AMENDMENT UNDER 37 C.F.R. § 1.111 Attorney Docket No.: Q80165

Application No.: 10/589,611

AMENDMENTS TO THE DRAWINGS

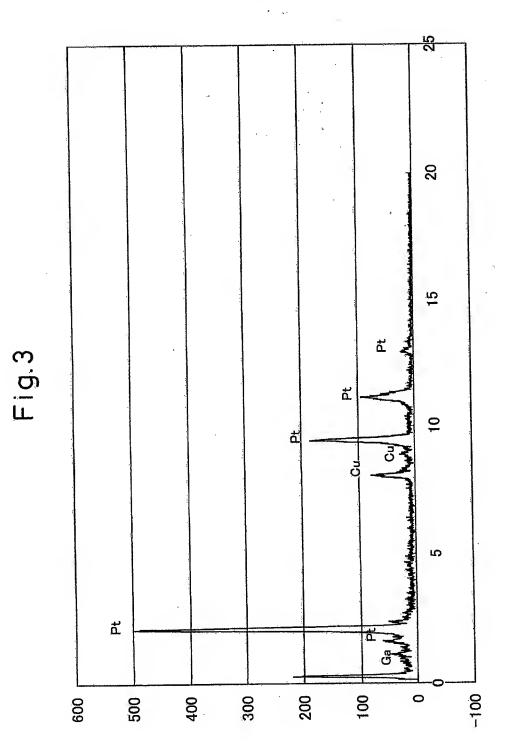
The Examiner objected to the drawings to under 37 C.F.R. § 1.83(a) as not showing the

contact metal layer and a positive-electrode-metal-containing layer as described in the

specification.

In response to the drawing objection, a replacement drawing sheet (Figure 2) is submitted

herewith to show a contact metal layer 11, a positive-electrode-metal-containing layer 6, and a

semiconductor-metal-containing layer 7.

In response to the drawing objection, a replacement drawing sheet (Figure 2) is submitted

herewith to show a contact metal layer and a positive-electrode-metal-containing layer including

identifying reference numbers. Figure 2 also shows a semiconductor-metal-containing layer,

which is described in the original claim 8.
